APPEAL BY ROBERT HITCHINS LTD

LAND AT OAKLEY FARM, CHELTENHAM

**PROOF OF EVIDENCE OF
G EVES BSc CEng MICE MCIHT**

Road Safety Audit Report

Drawing No. **H628/04** Rev C

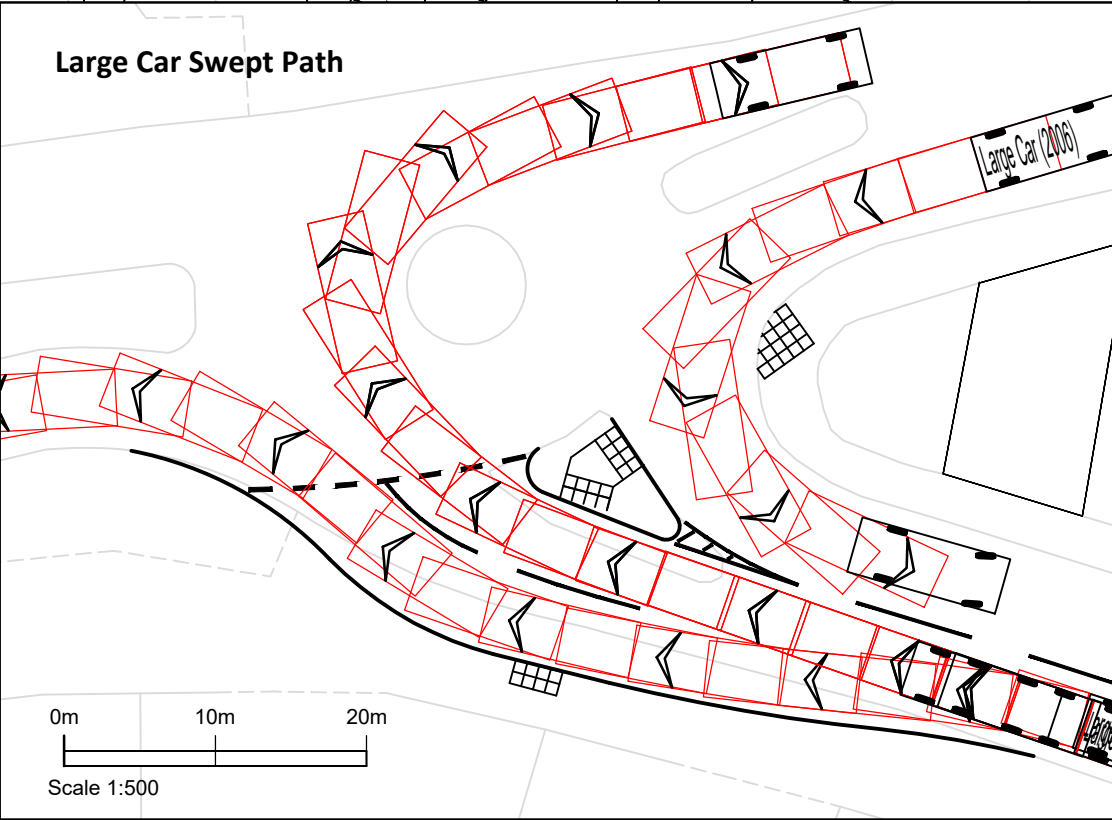
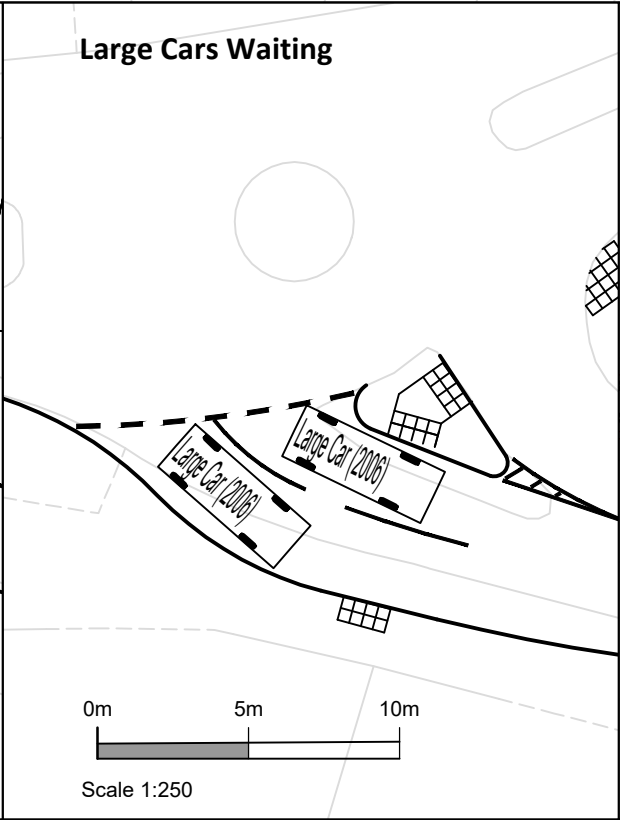
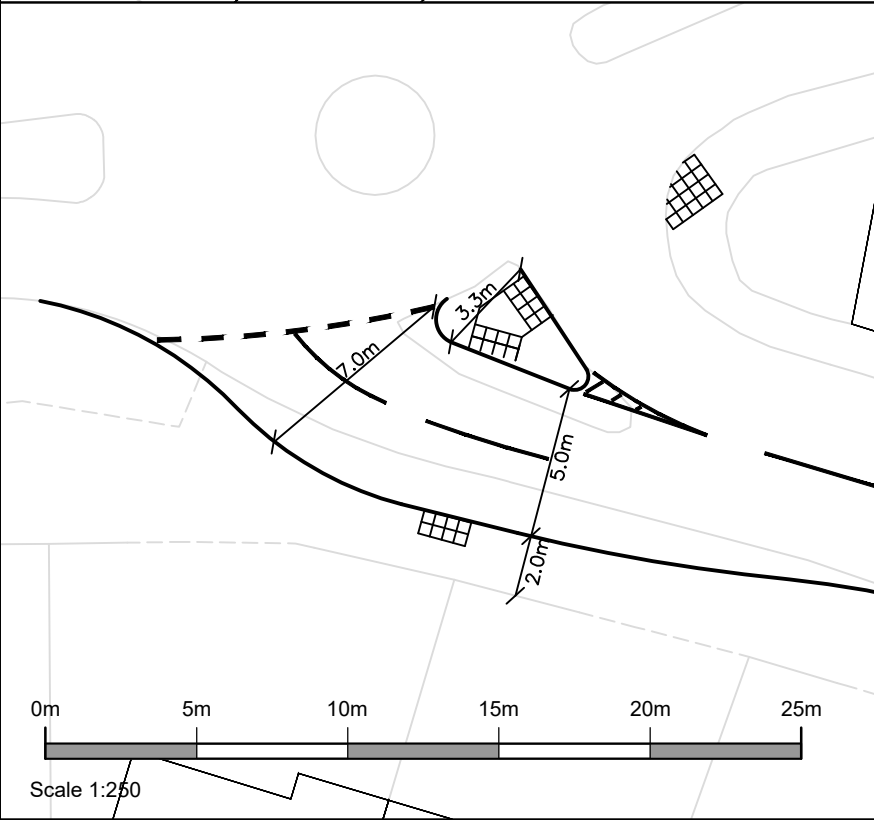
The existing Harp Hill entry to its mini-roundabout with the A4075 Priors Road accommodates a single lane that approaches at approximately 45° before turning to meet the Priors Road carriageway at almost 90° in order to maximise visibility. The proposals that are subject to this Stage 1 Road safety Audit, include the provision of a two entry lane on Harp Hill to be accommodated by reducing the width of the central refuge island as well as widening on the nearside. The widening of the carriageway by reducing the refuge island will result in vehicles approaching and meeting the mini-roundabout junction at 45°. Whilst visibility to the right of a vehicle that meets a major road at 45° does not always raise road safety concerns, the provision of a two lane entry at this angle coupled with the reduction in visibility over the existing situation could lead to a vehicle proceeding when it is not safe to do so.

It is recommended that an offside radius is provided on the refuge island and the proposed give-way line is adjusted to maximise visibility whilst not restricting existing movements to the western arm of Priors Road.

As recommended, it is agreed that the centreline on Harp Hill be realigned to ensure traffic turning left from Priors Road will not encroach the opposing lane. PFA drawing H628/04 Rev C at Appendix A3 includes for the realignment of the centreline and the associated changes to the inside kerb line on the Harp Hill approach.

As recommended, it is agreed that the radius of the refuge island and give way line be adjusted to improve visibility, as shown in PFA drawing H628/04 Rev C at Appendix A3.

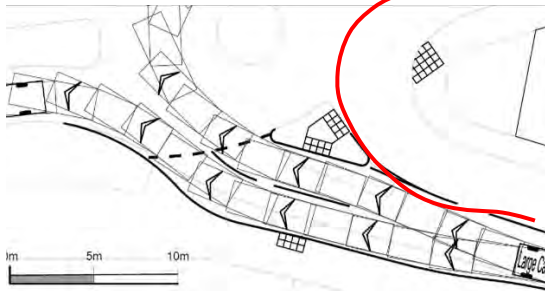
A.1	LOCAL ALIGNMENT			
A.1.1	PROBLEM			
Location:	Harp Hill			
Summary:	Vehicles turning left into Harp Hill will encroach the opposing lane of traffic			
Acc Type:	Sideswipes			
<p>Harp Hill meets the B4075 Priors Road at an angle of circa 45° with a circa 3.5 metre inside radius for traffic turning left into Harp Hill from Priors Road. The Harp Hill arm accommodates a single entry with a road centreline that splits on approach to the over-runnable refuge island that divides the entry and exit lanes with an area of hatching. Vehicles that turn left into Harp Hill were observed to cross the road centreline and encroach the hatching. This does not raise road safety concerns at present as traffic approaching the mini-roundabout along Harp Road should not encroach the hatching. The proposals that are subject to this Stage 1 Road Safety Audit, include the widening of the Harp Hill entry to provide two entry lanes. The proposed widening is to be provided on both sides of the carriageway with the footway on the southern side of Harp Hill reduced to 2.5 metres and the width of the refuge island reduced as well as road centreline realigned removing the area of central hatching on the approach to the island. The realignment of the road centreline and removal of the hatching is likely to result in a vehicle turning left from Priors Road to Harp Hill, encroaching the opposing approach lane on Harp Hill. Whilst this does not always raise road safety concerns, a vehicle travelling along Harp Hill and wishing to turn right along Priors Road is likely to be abutting the road centreline. This, compounded by the restricted visibility between a left turning vehicle on Priors Road and the expected path of a vehicle approaching the roundabout on Harp Hill due removal of the hatching, could lead to sideswipe type collisions.</p>

Severity/Frequency	Frequent	Probable	Occasional	Remote
Fatal Injury	Very High	High	High	Medium
Serious Injury	High	High	Medium	Medium
Slight Injury	High	Medium	Medium	Low
Damage Only	Medium	Low	Low	Low
RECOMMENDATION:				
<p>It is recommended that the westbound road centreline of Harp Hill is realigned to ensure sufficient space is provided for traffic to turn left from Priors Road without encroaching the opposing lane.</p>

Item Location Plan

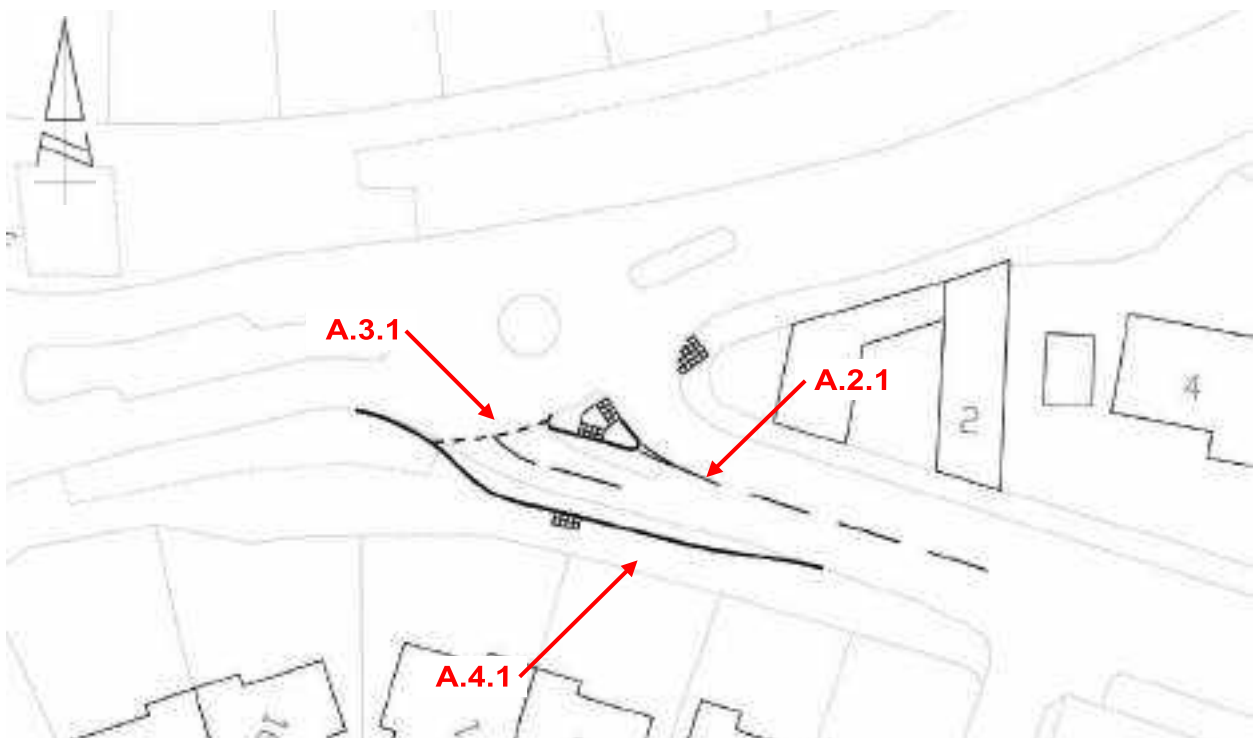
The existing footway to the south of the Harp Hill carriageway is wide and accommodates a number of vehicular crossovers linking to the driveways / frontages of properties. The proposals that are subject to this Stage 1 Road safety Audit, include a reduction in the width of the footway to 2.5 metres in proximity to the Harp Hill approach to the mini-roundabout junction with Priors Road and driveway associated with property number 3 Harp Hill. The frontage of property number 3, is set above the level of the footway and falls towards the footway with a section of the adjacent footway to the west, also set at a gradient making for an uneven surface. Whilst this does not raise road safety concerns at present due to the width of the footway and presence of vegetation to the east of the access guiding pedestrians away from the uneven surface (which should not encroach the public highway), the reduction in width could result in pedestrians walking closer to the back edge of footway where the uneven surface could lead to a trip / fall and personal injury.

It is recommended that the footway in the immediate vicinity of the vehicular crossover is regraded to ensure a smooth surface.
